UNITED STATES PATENT AND TRADEMARK OFFICE

APPLICATION NO.	FILING DATE	FIRST NAMED INVENTOR	ATTORNEY DOCKET NO.	CONFIRMATION NO.
09 927,368	08.13.2001	Hisaya Mori	50090 332	4507

Office Action Summary

DETAILED ACTION

FIG. 4

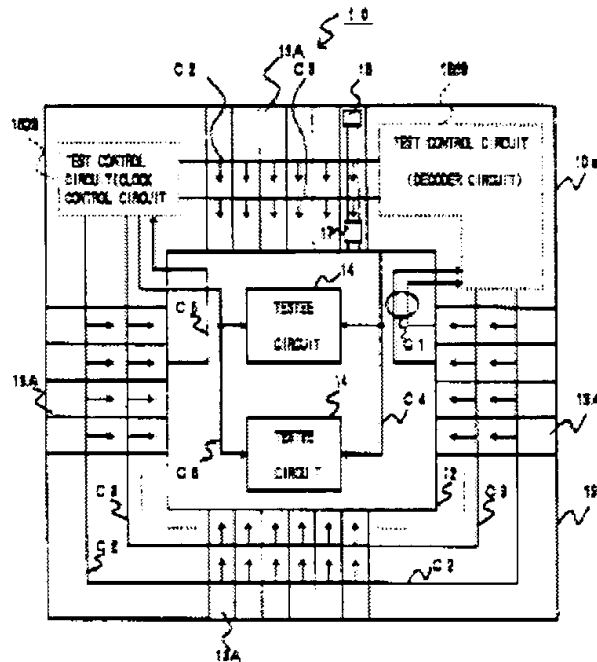
Yamamura ('019) discloses a semiconductor integrated circuit including a board (chip 10a) for testing functions of an internal circuit in a integrated circuit (see col. 1, lines 9-10) and specifically teach to have test ancillary device (15) disposed in the vicinity of the chip (see Fig 4, below)

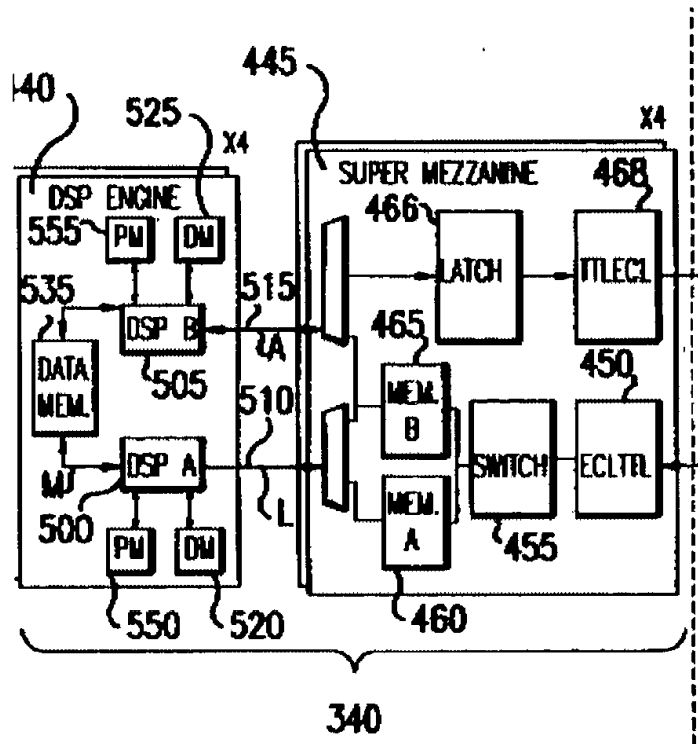
Rosenthal et al ('521) disclose mixed-signal tester architecture of the IXD7232 board (fig 4, below and col. 7, lines 14-15) comprising multi-bank capture memory for storing test data and particularly teach when digital test data is stored in one memory section (460), digital test data previously stored in the other memory section (465) is loaded for analysis purpose (see Abstract, last 6 lines, and col. 7, lines 33-39).

Rosenthal et al ('521) disclose mixed-signal tester architecture of the IXD7232 board (fig 4, below and col. 7, lines 14-15) comprising multi-bank capture memory for storing test data and particularly teach when digital test data is stored in one memory section (460), digital test data previously stored in the other memory section (465) is loaded for analysis purpose (see Abstract, last 6 lines, and col. 7, lines 33-39).

FIG. 2

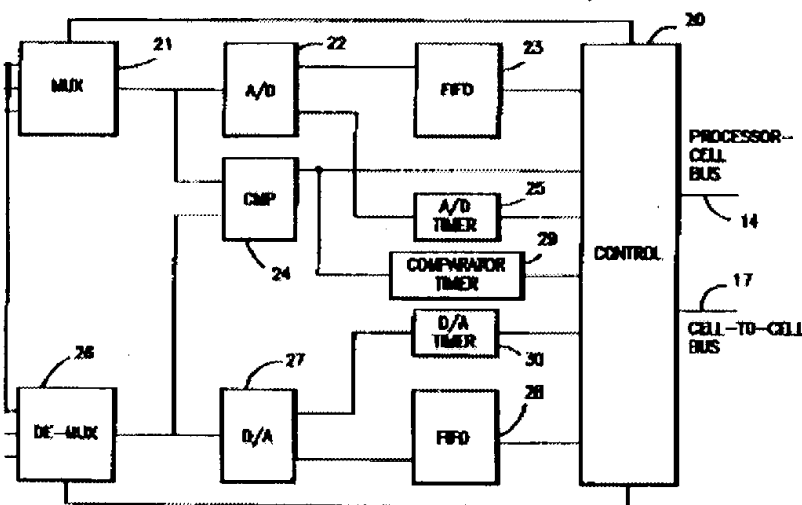
Coggins et al ('365) disclose a diagnostic apparatus for testing an analog circuit (see Fig 2) below and specifically teach that his semiconductor integrated circuit (15) includes both an analog-to-digital converter circuit (22) and digital-to-analog converter circuit (27), a source analog signal (see col.3, line 25) to the semiconductor integrated circuit (15).
